From: Richard Purser
Sent: 01 September 2023 17:30
To: Gwyn Humphreys
Subject: RE: FIREM - Wrexham Industrial Estate applications

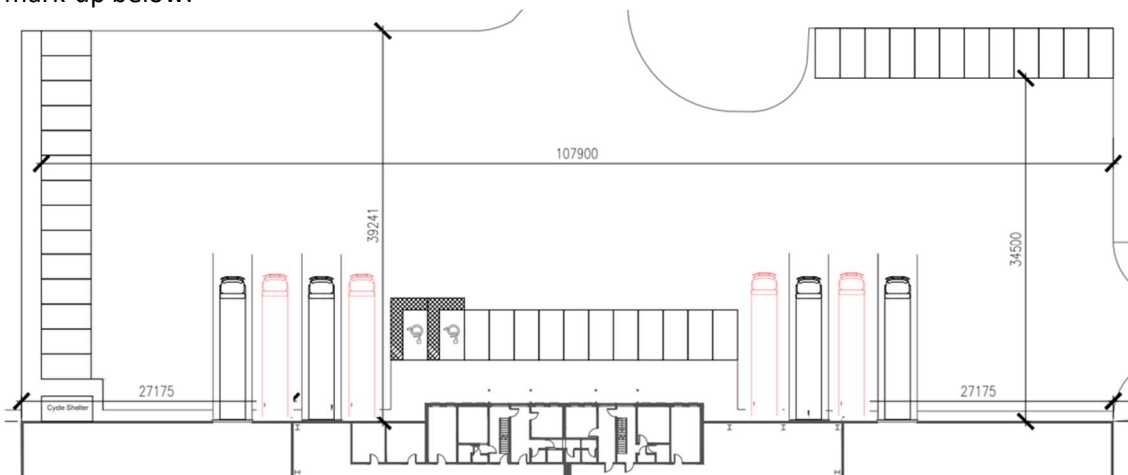
There is concern from the "ATC HGV Trip Generation" (in Table 2.4 of the response document dated 28/04/2023) regarding the number of HGVs on site in the peak hours and if the site has the capacity (4 HGV spaces are shown on plan P22015-002) for over 4 HGVs. If not, there is a risk that HGVs waiting to access the site may park on the public highway which would be a safety concern.

Further clarification is required regarding the HGV trip generation and the number of HGVs which can be accommodated on site.

The layout includes four HGV loading bays. There is parking space for a further 4 HGVs on site if required as per the mark-up below:

The 8 potential rigs on site would meet the concern from the Highway Authority about waiting to access should more than 4 be present at once. We have also asked DP about its planned future operation and whilst the number of movements is not expected to fall but they expect to have a faster turnover of HGVs on site from efficiency of operations so the prospect of parking additional rigs should be limited rather than routine.
